ADDENDUM NO. 03

DATE: May 5, 2020

PROJECT: Inglemoor High School Concert Hall + Music Building Project

SHEET A4.46 – Interior Details - Lobby

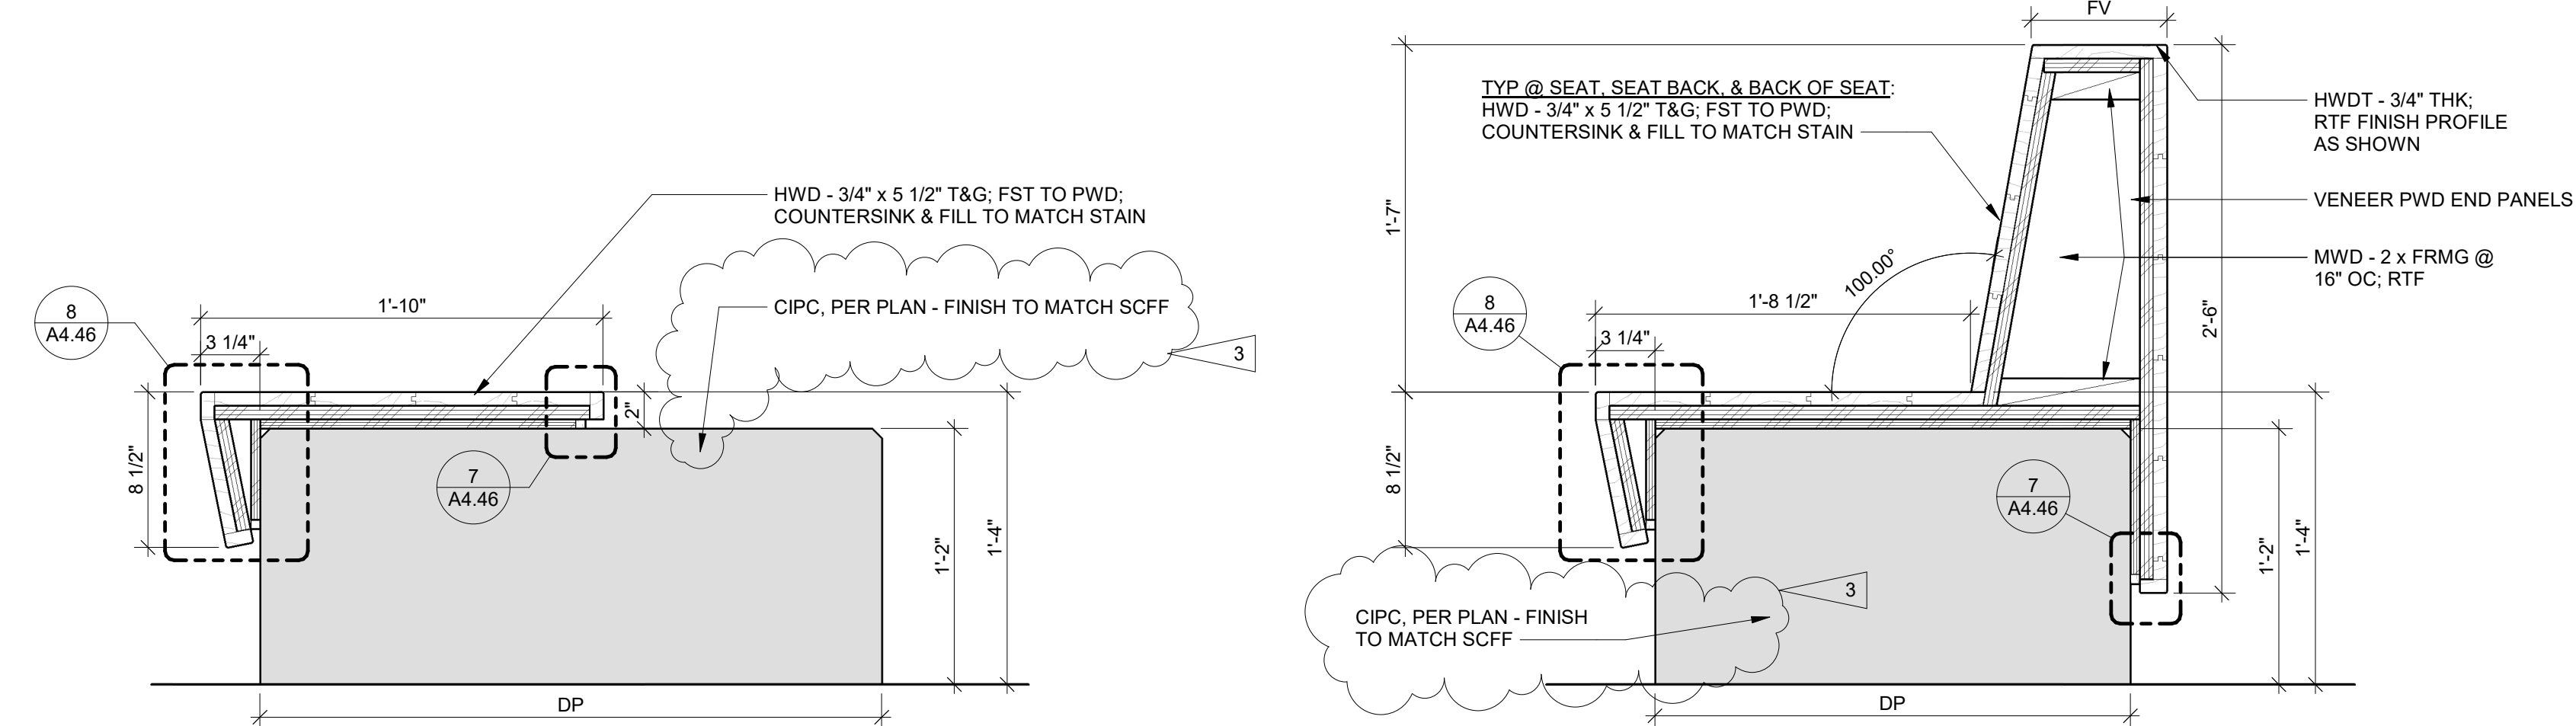
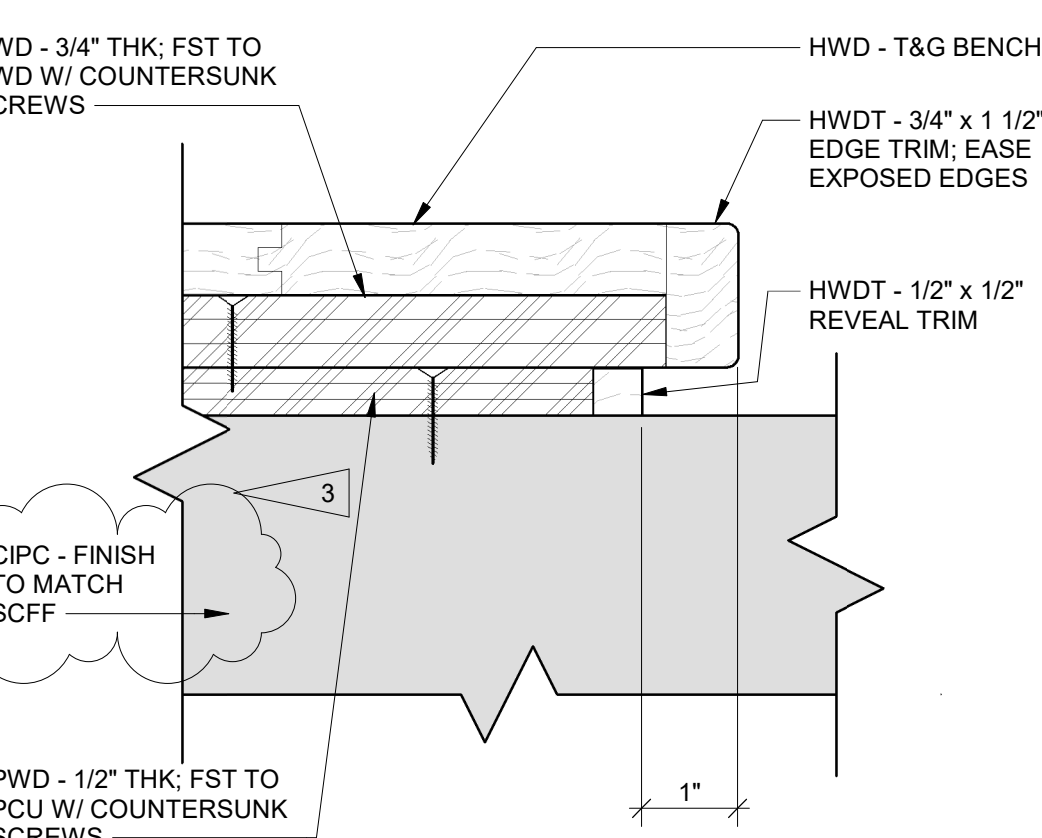
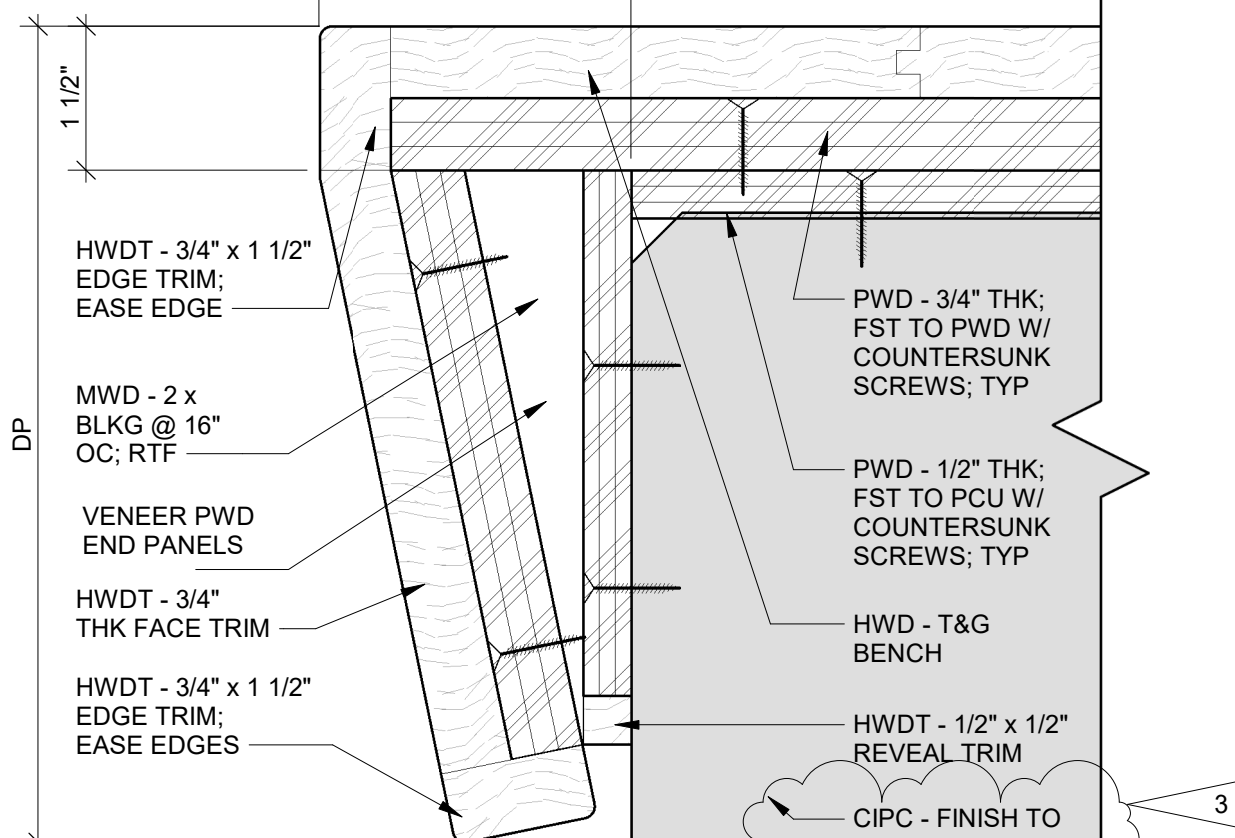
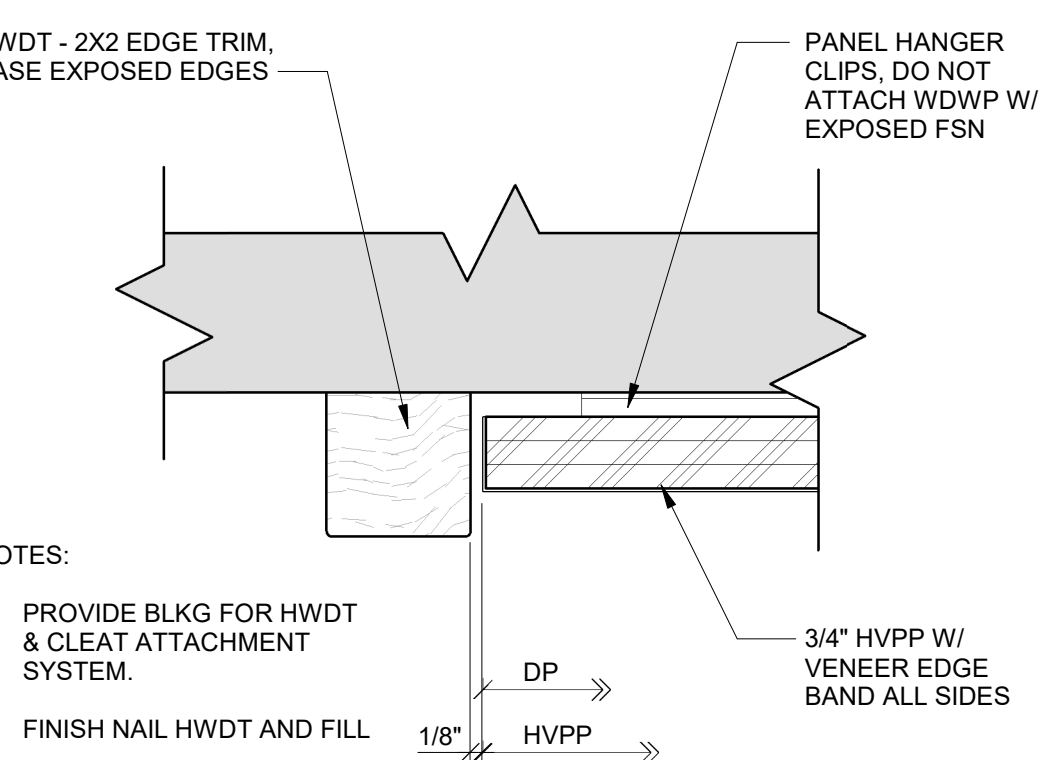
1. *QUESTION: Reference bench details on sheet A4.46. It looks like the sheet is asking for a solid bench at the north and south location if you look at the cross section drawings shown below, however if I look at the stair drawings on 2/A9.12 they appear to be hollow. Can you please let me know which direction we should take on these precast benches?*

1. On Detail 1, 2, 7, and 8, REVISE per attachment A4.46

ANSWER: Reference Addendum 3 from Hutteball + Oremus, these benches have been changed to cast in place.
